MALAYSIAN NOTICES TO MARINERS

Monthly Edition 08 of 2017
31st AUGUST 2017

Block for Chart MAL 5416

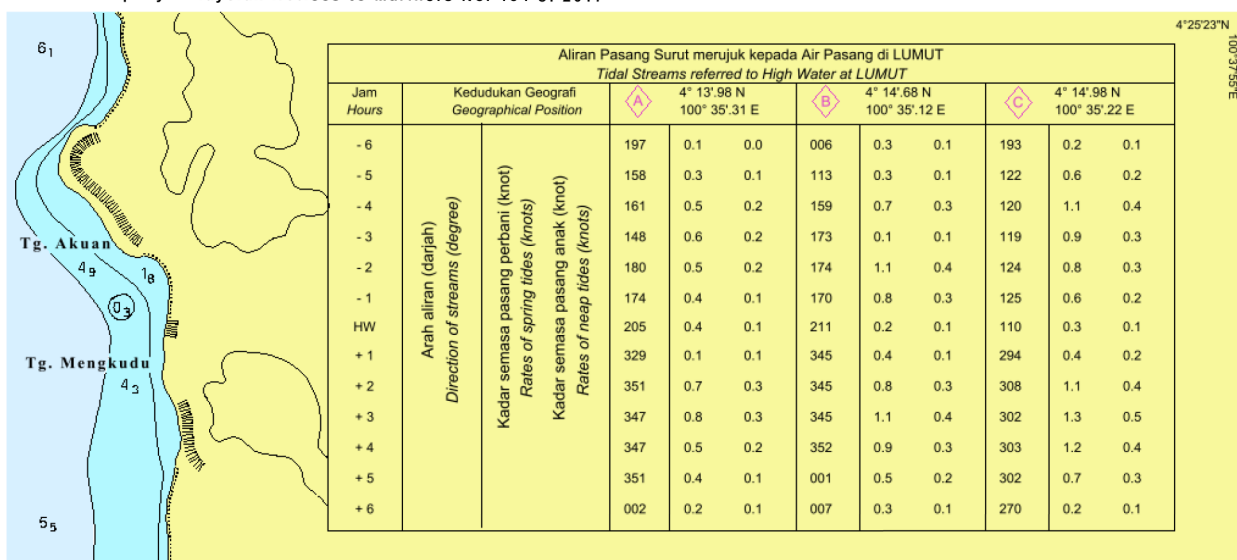
Insert	the accompanying block, <i>Tidal Streams</i> centred on:	04° 14'.20N, 100° 39'.45E
---------------	---	---------------------------
